# **Wollar to Wellington 330kV Transmission Line**

## **SUBMISSIONS REPORT**

**A REPORT TO THE  
MINISTER FOR PLANNING**

March 2006

**Figure 1 – Far Western Area: Maximum Demand and Supportable Load**

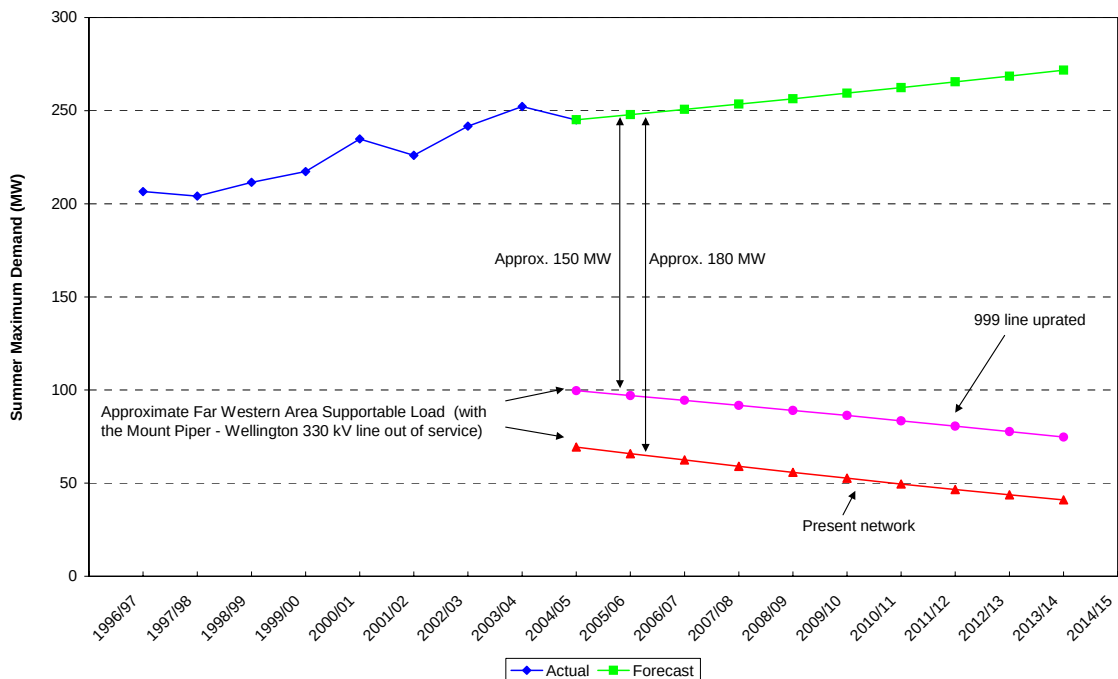
- (a) The peak demand growth figures of the EIS compared with those of the TransGrid 2005 Annual Planning Report (APR). One submission described these figures as “overblown and Inconsistent”.
- (b) The justification for the proposed line given the slow peak demand (8MW per year) as stated in the 2005 Annual Planning Report.

A slower rate of peak demand growth does not mitigate the need for this project, because the N-1 reliability standard is currently being exceeded, and by a clear margin, as illustrated in the above table and the graphs in Figure 1 below. A similar situation existed in 2003, when the 10 system-minute standard was being exceeded at that time, for the actual loads in the previous few years.

The difference between the upper and lower curves is indicative of the amount of generation (at Wellington) that would be required to achieve the N-1 standard, viz. in excess of 150 - 180 MW.
